Title: Pneumatic Clutch III (2017) – Pressure Disc Inspection		
AG-SB-2018-05-B-EN		Compliance Category:
Applicability		A – MANDATORY B – RECOMMENDED C – OPTIONAL
Aircraft type & model: All MTO2017 and all Calidus/Cavalon with rotor head III fitted	Affected Serial number(s): All MTO2017 and all Calidus/Cavalon with rotor head III fitted	
The maintenance manual to be referenced is this stated or subsequent issue.		As per AutoGyro website
This form is the response from AutoGyro GmbH either against a problem found in the product in service requiring a containment or rectification action, or as service information for aircraft modification incorporation. For help, contact AutoGyro on 49(0)5121 88056-00, or email airworthiness@auto-gyro.com .

Fig. 1 - Pressure Plate Assembly (31713)

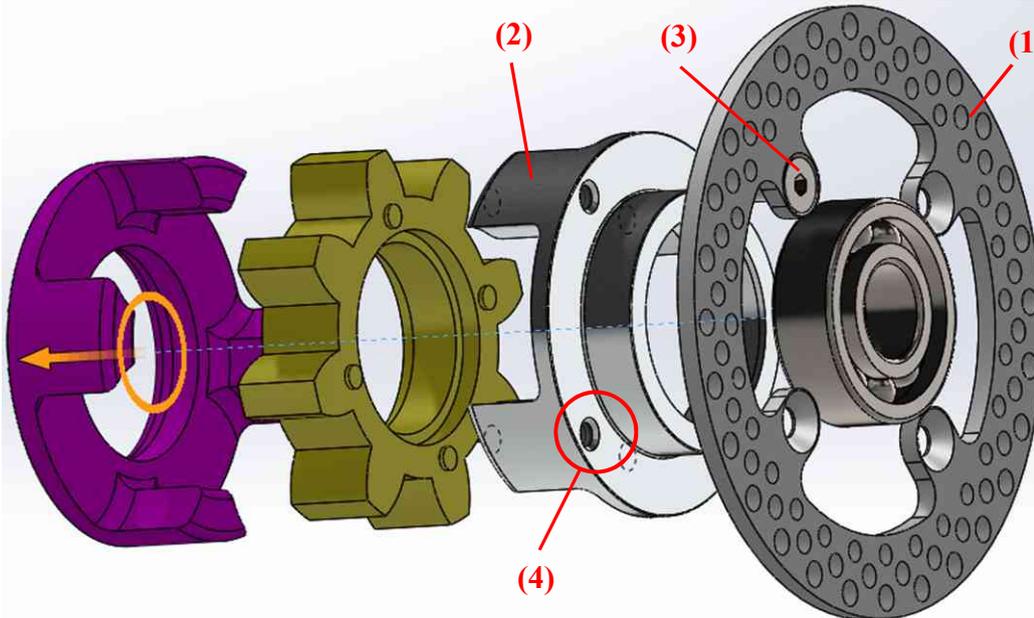
It has been found that the threaded holes in the first batch of pneumatic clutch III (2017) Pressure Plate front (2) are not sufficiently countersunk to accept the countersunk screws securing the Pressure Disc PKII (1). The effect is that the screws are unable to properly clamp the disc and plate together, possibly leading to looseness, rattle noise, and wear of this connection.

1. Remove any cowlings required to gain access to the clutch assembly.
2. Remove the pneumatic clutch from the engine in accordance with AMM job card 63-11-10 4-1.
3. Remove the center screw retaining the pressure plate assembly (31713) to the clutch in accordance with AMM job card 63-11-10 8-1 part 4.
4. Remove the pressure plate assembly (31713) from the clutch and remove the 4 countersunk screws (3) securing the pressure disc (1) to the pressure plate front (2).
5. Inspect for signs of rotational movement of the pressure disc (1) on the pressure plate front (2), and/or elongated holes in the disc (1). If damaged, replace (article 23604).
6. Inspect the complete clutch assembly for any further damage and replace any affected parts (eg. 31713 Pressure Plate Mounted).
7. Inspect the pressure plate front (2) and ensure that the threaded holes (4) are countersunk to a

- depth of 1mm with a 45° countersink. If not, re-work with a suitable countersink tool.
8. Re-assemble the clutch in reverse order of disassembly.
 9. Assemble the clutch to the engine in accordance with AMM job card 63-11-10 4-1.
 10. Re-fit any cowlings previously removed.
 11. Ground run the aircraft in a suitably secured area, including a pre-rotation clutch functional check.
 12. Note the SB action within the aircraft documentation.
